Access Compliance Report

Intersection ID: 10033355	Main Street: OLD_ARDREY_KELL_RD	Cross Street: N/A	Location: NE
ADA ID: 89B09BDDEB8C	Ramp Type: Perp	Initial Pass/Fail: Fail	Overall Compliance: No
Severity Score: 12.5			
Codes/Mitigation Info/Possible Solution		Field Measurements/Component Compliance

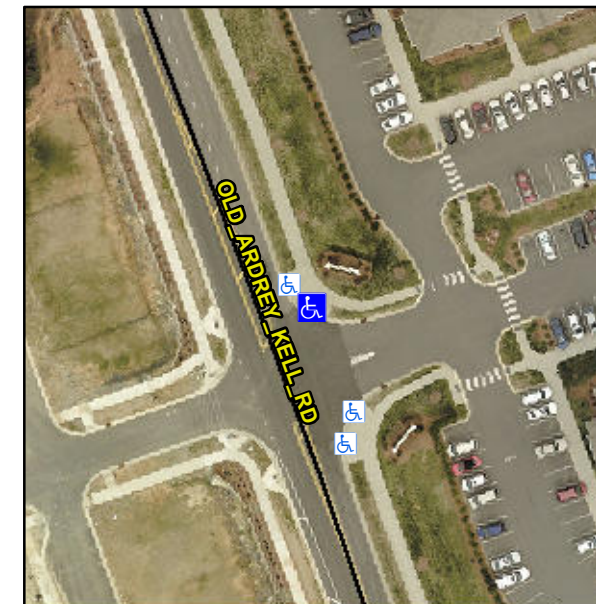
Not Found, R304.2.2

Compliance	Description	Data	Compliance	Description	Data
N/A	Ramp Length (in)	87.0	No	Ramp Slope (%)	8.5
Yes	Ramp Width (in)	48.0	Yes	Ramp XSlope (%)	1.9
N/A	Flare Type LT	N/A	N/A	Flare Type RT	N/A
N/A	Flare Slope LT (%)	N/A	N/A	Flare Slope RT (%)	N/A
N/A	Flare Traversable LT?	N/A	N/A	Flare Traversable RT?	N/A
N/A	Landing Length (in)	N/A	N/A	DWS Provided?	N/A
N/A	Landing Width (in)	N/A	N/A	DWS Contrast?	N/A
N/A	Landing Slope (%)	N/A	N/A	DWS Length (in)	N/A
N/A	Landing X Slope (%)	N/A	N/A	DWS Full Width?	N/A
N/A	Landing Curb? (Y/N)	N/A	N/A	DWS Offset (in)	N/A
N/A	Shared Landing?	N/A			
N/A	Gutter Ponding?	N/A	N/A	Gutter Slope (%)	N/A
N/A	Gutter Lip Ht (in)	N/A	N/A	Gutter X Slope (%)	N/A
N/A	Painted X Walk1?	No	N/A	Painted X Walk2?	N/A
	X Walk 1 Direction	To S		X Walk 2 Direction	N/A
N/A	X Walk 1 Width (in)	N/A	N/A	X Walk 2 Width (in)	N/A
	X Walk 1 Slope (%)	2.7		X Walk 2 Slope (%)	N/A
	X Walk 1 X Slope (%)	1.2		X Walk 2 X Slope (%)	N/A

Remove & Replace Entire Ramp.
